RE: Phased Subdivision Application for 6719 Devon Avenue SE (AMANDA 20-118048-LD)

PW Completeness Review_Civil Plans_Devon Estates.pdf Markup Summary

P406

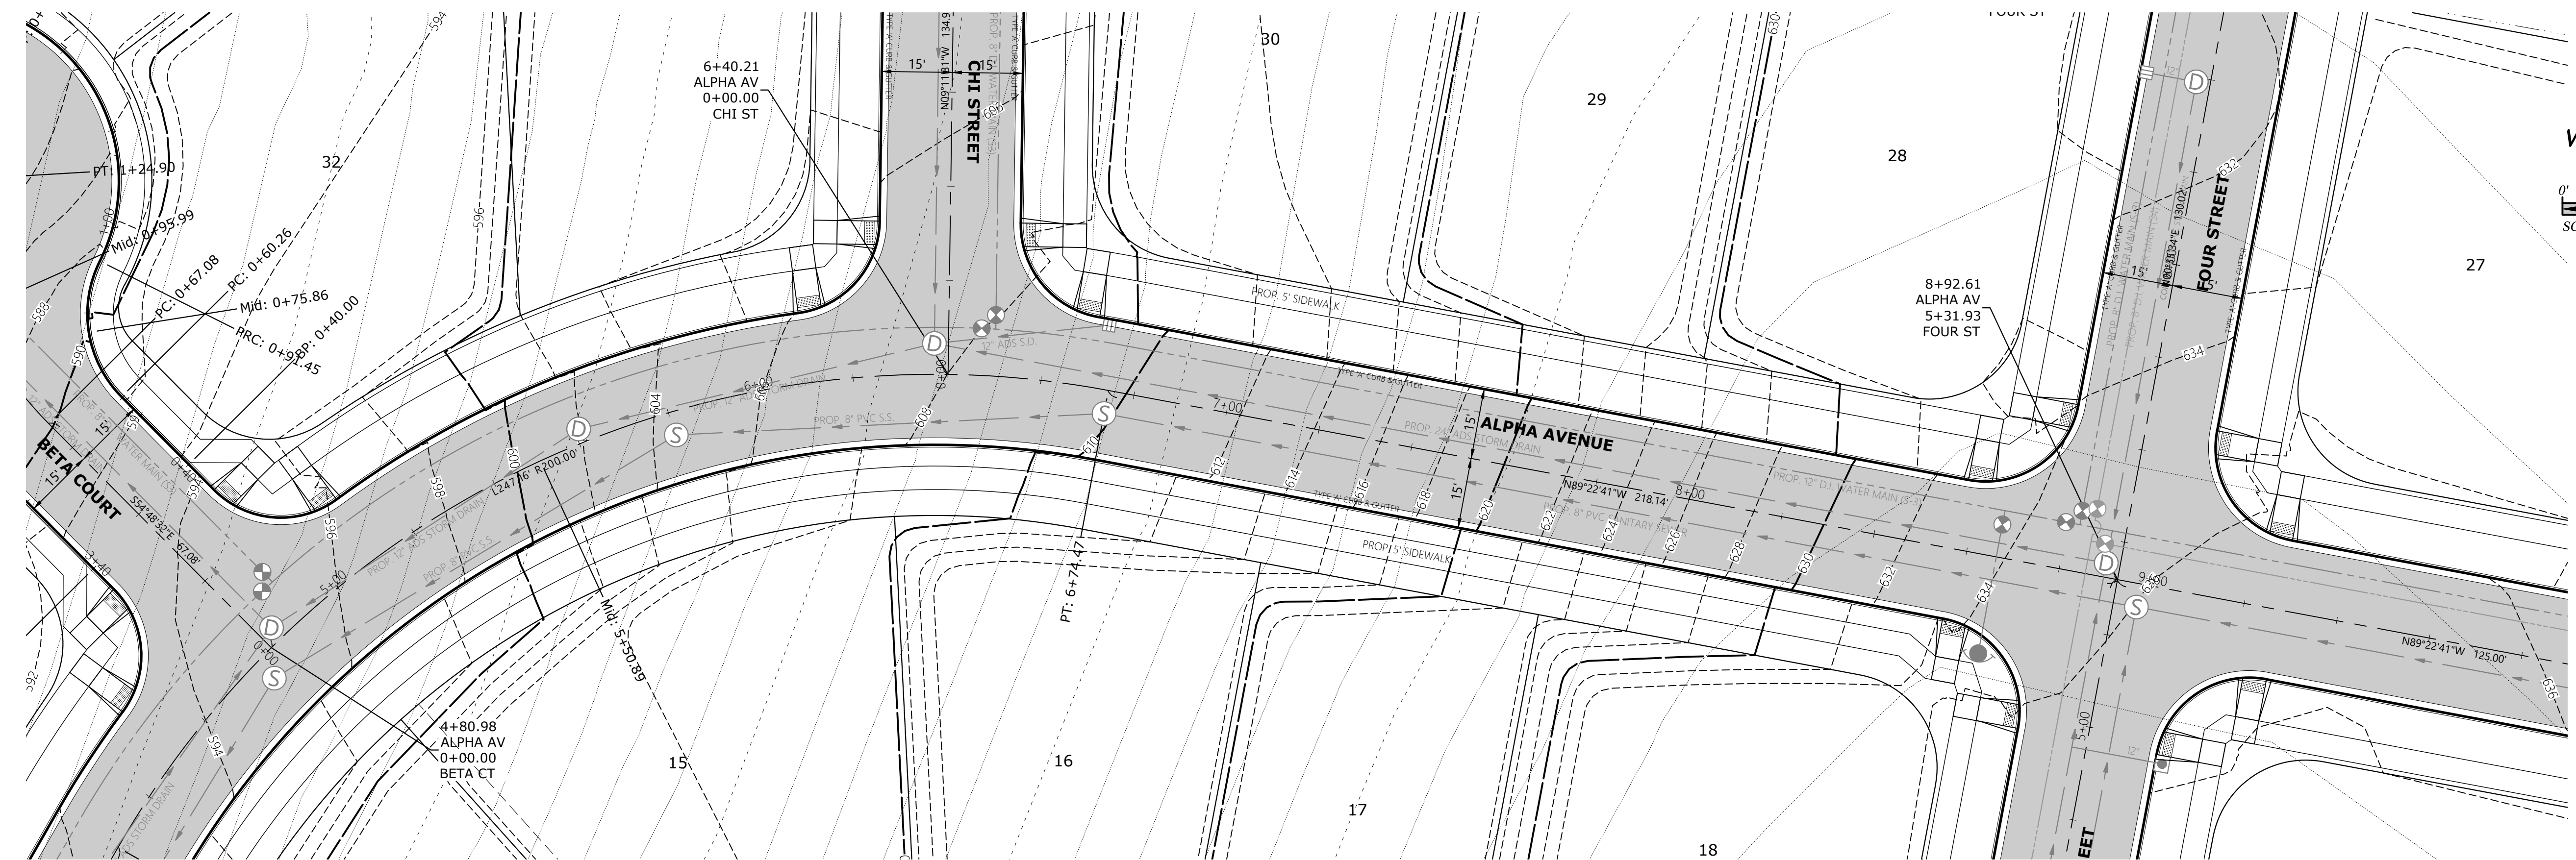
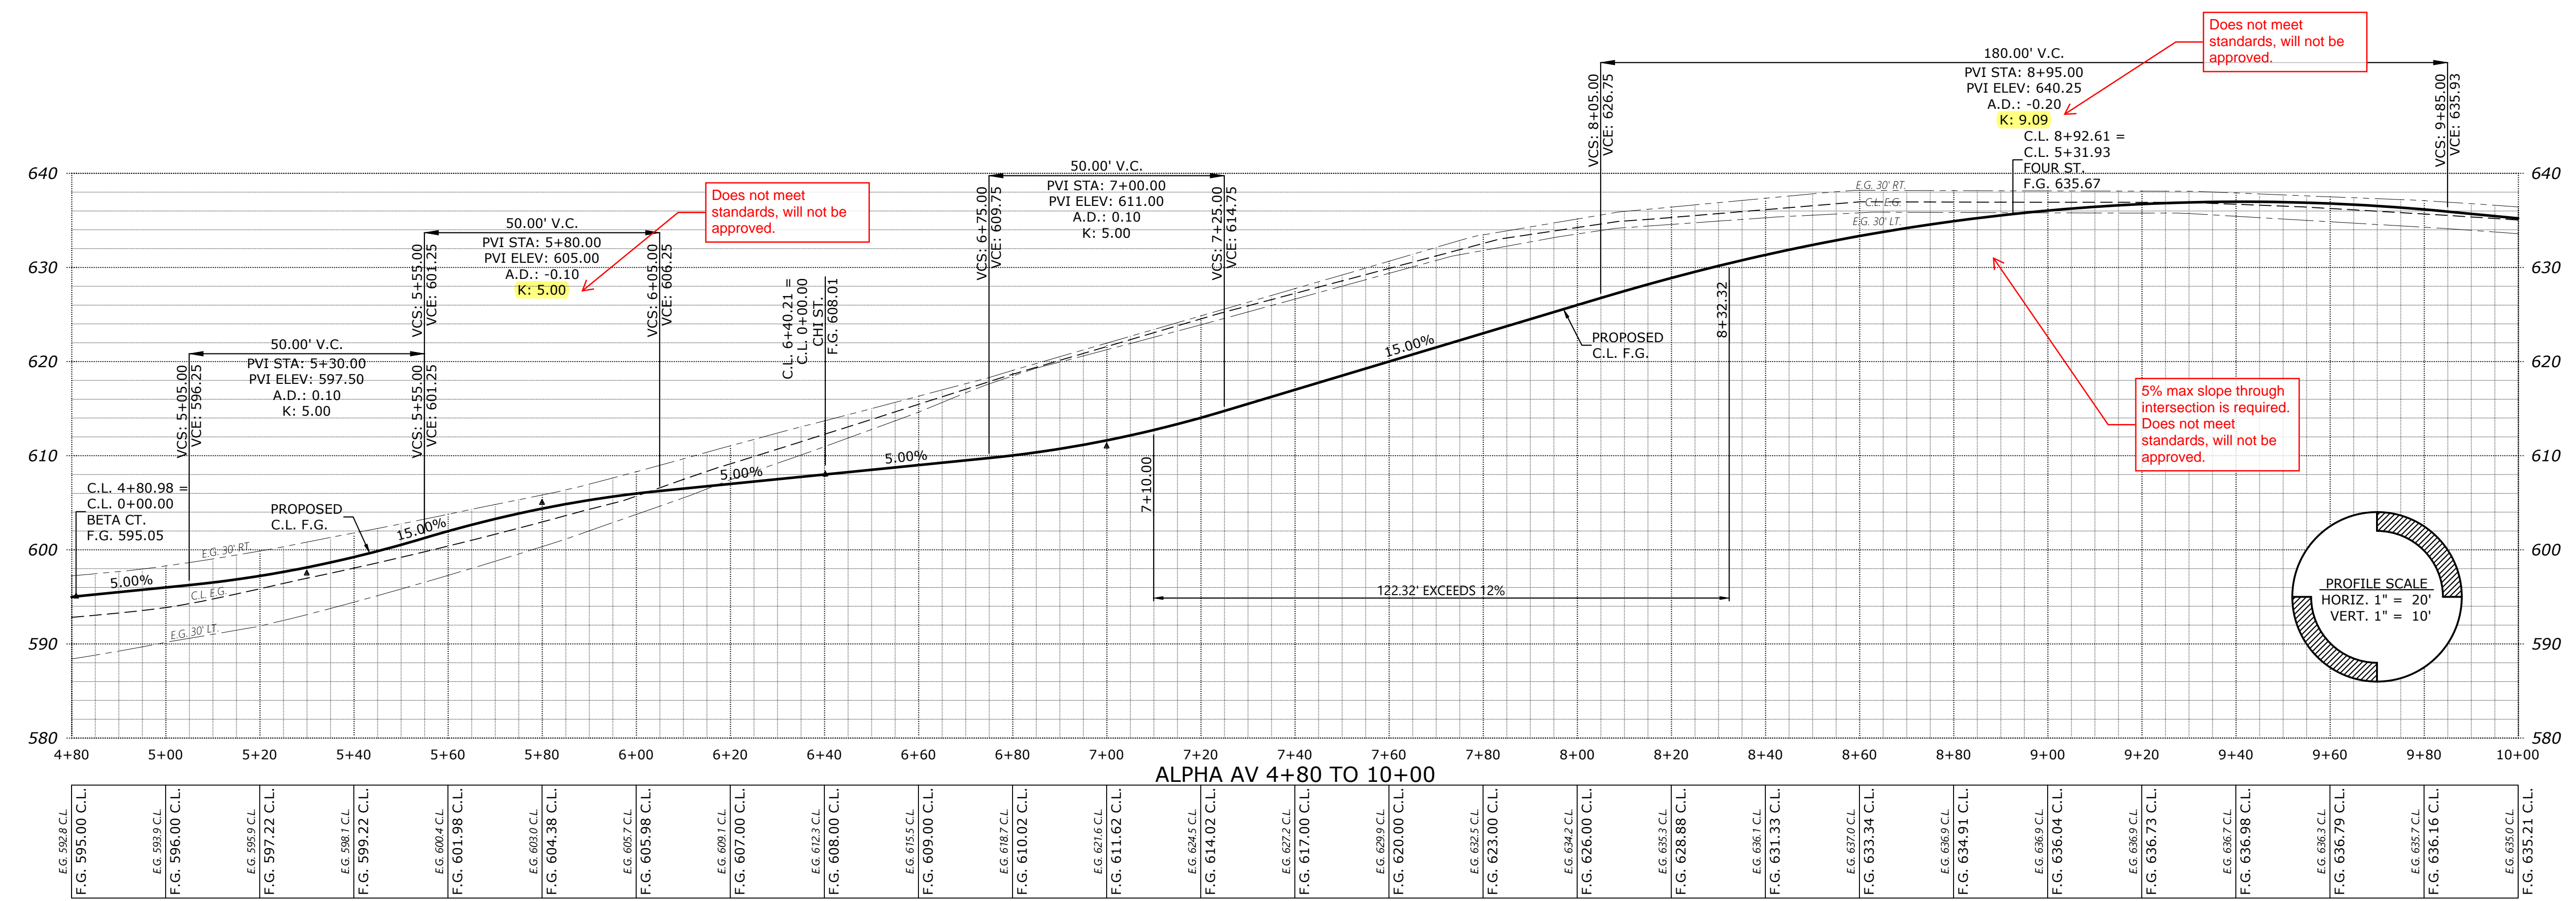
Does not meet standards, will not be approved.

Does not meet standards, will not be approved.

5% max slope through intersection is required.
Does not meet standards, will not be approved.

Does not meet standards, will not be approved.

Does not meet standards, will not be approved.

5% max slope through intersection is required. Does not meet standards, will not be approved.
